**Addendum No. 01**

Subject: **Marin Classroom Modernization Project  
B-024C, B-025C of 2018/19**

Location : **Marin Elementary School  
3<sup>rd</sup> and Ontario Streets  
Philadelphia, PA 19140**

This Addendum, ***dated February 2<sup>nd</sup>, 2019***, shall modify and become part of the Contract Documents for the work of this project. Any items not mentioned herein, or affected by, shall be performed strictly in accordance with the original documents.

DRAWING NO.  
**ED - 102.0**  
SHEET 20 OF 27

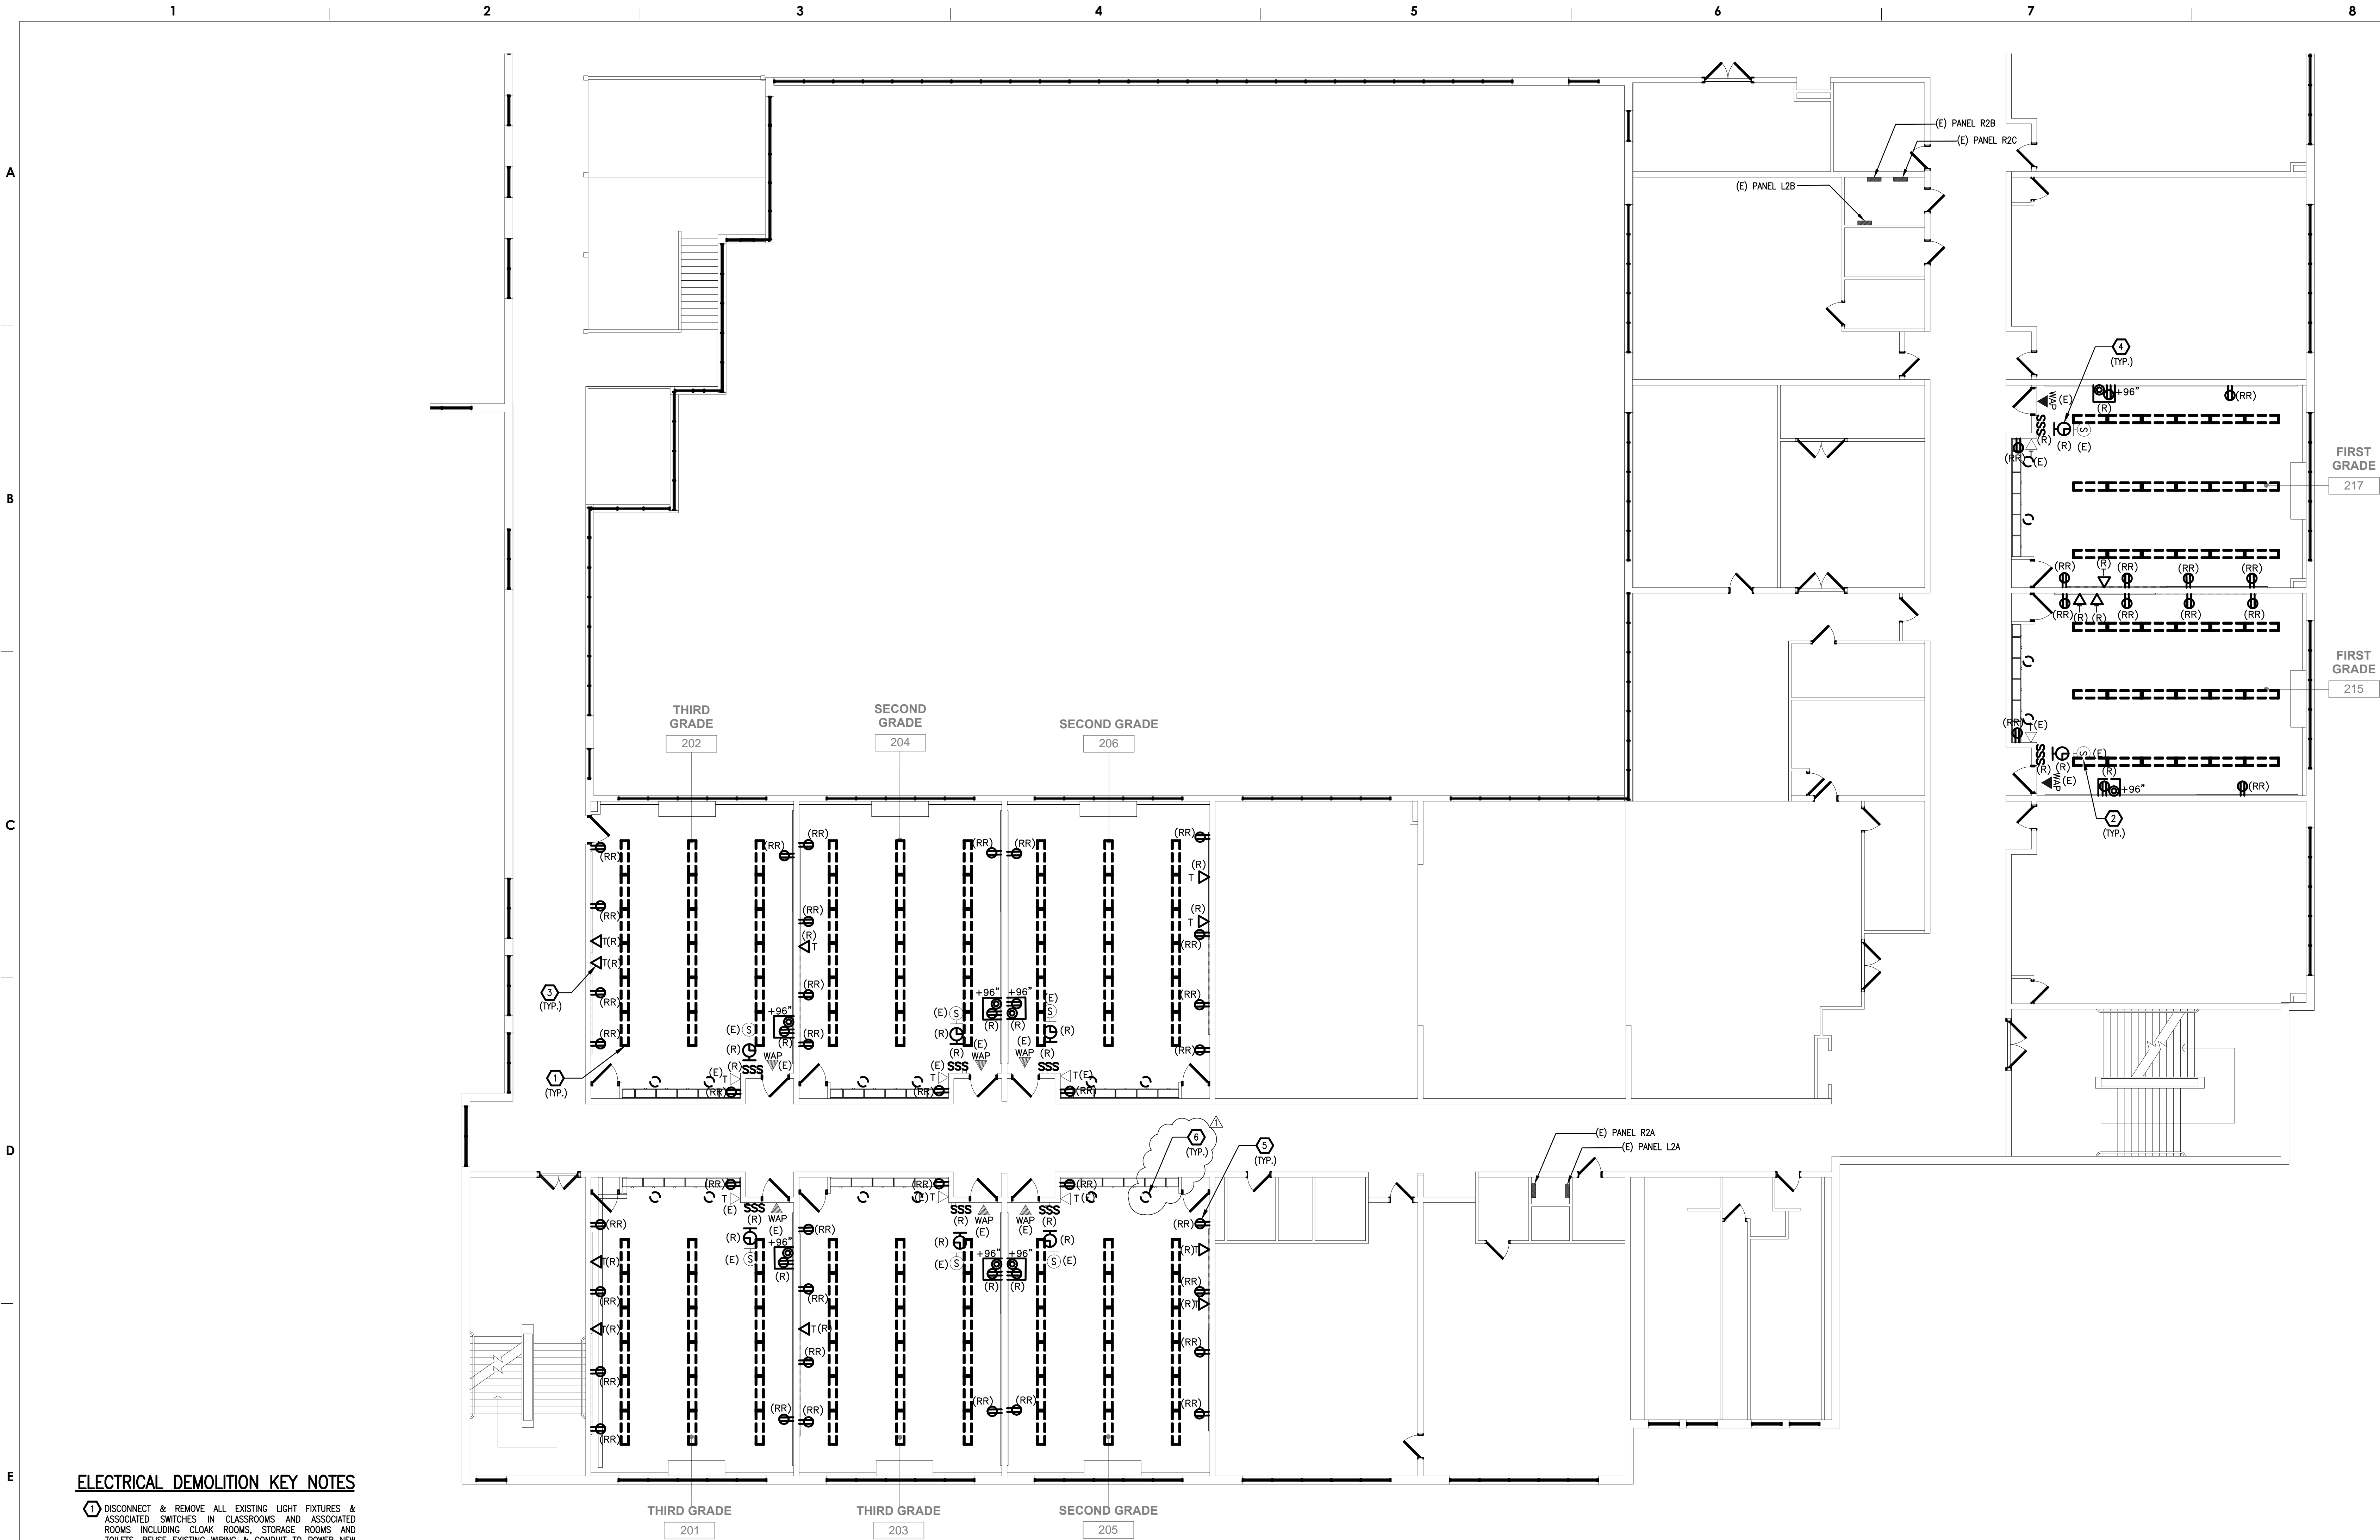
**For changes see drawing ED102.0 Rev1 dated 2/8/19 issued with this Addendum.**
